Project Address: 4323 East Towne Boulevard
Application Type: Conditional Use
Legistar File ID # [30658](#) and [29803](#)
Prepared By: Kevin Firchow, AICP, Planning Division
Report Includes Comments from other City Agencies, as noted

Requested Action: The applicant requests conditional use approval to amend the existing Planned Multi-Use Site and to allow outdoor seating.

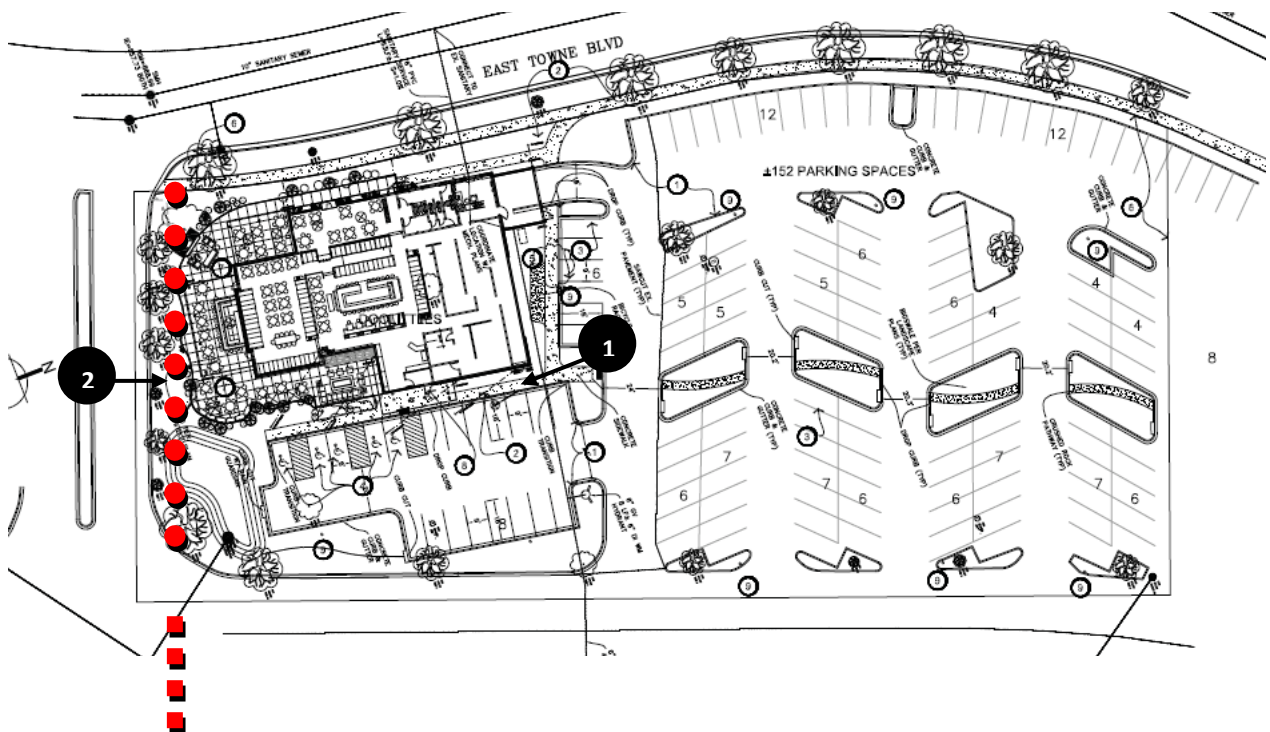
Standard 5 states that “Adequate utilities, access roads, drainage, parking supply, internal circulation improvements, including but not limited to vehicular, pedestrian, bicycle, public transit and other necessary site improvements have been or are being provided.” In regards to that standard, staff recommends the following pedestrian-related improvements, noting that the site sits directly across from a recently installed bus stop on the private inner ring-road. The general location of these recommendations are noted on the below graphic.

1. Widen the private sidewalk leading from the parking lot to the main door from five (5) to six (6) feet. Currently, there is nine feet between the building and the parking stalls. This would result in the associated landscape area being reduced in size by roughly one foot.
2. Install a five (5) foot wide sidewalk adjacent to existing trees along the mall ring-road. (Between the existing trees and the proposed patio area). Minimally, staff recommends that a sidewalk be extended from East Towne Boulevard to East Towne Way (private street). A cross walk should be added to connect to the sidewalk on the opposite side of East Towne Way.
3. Provide a direct pedestrian route connecting the main building entrance to the bus stop on the opposite side of East Towne Way.

1. That the proposed 5 foot sidewalk along the front (east) side of the building, connecting the parking lot to the main building entrance be widened to 6 feet. Details shall be approved by the Planning Division and Traffic Engineering Division.

2. That the applicant installs a five (5) foot wide sidewalk adjacent to existing trees along the mall ring-road on the west side of the property. (Between the existing trees and patio area). Details shall be approved by the Planning Division and Traffic Engineering Division.

3. That a direct pedestrian route connecting the main building entrance to the bus stop on the opposite side of East Towne Way. Details shall be approved by the Planning Division and Traffic Engineering Division.
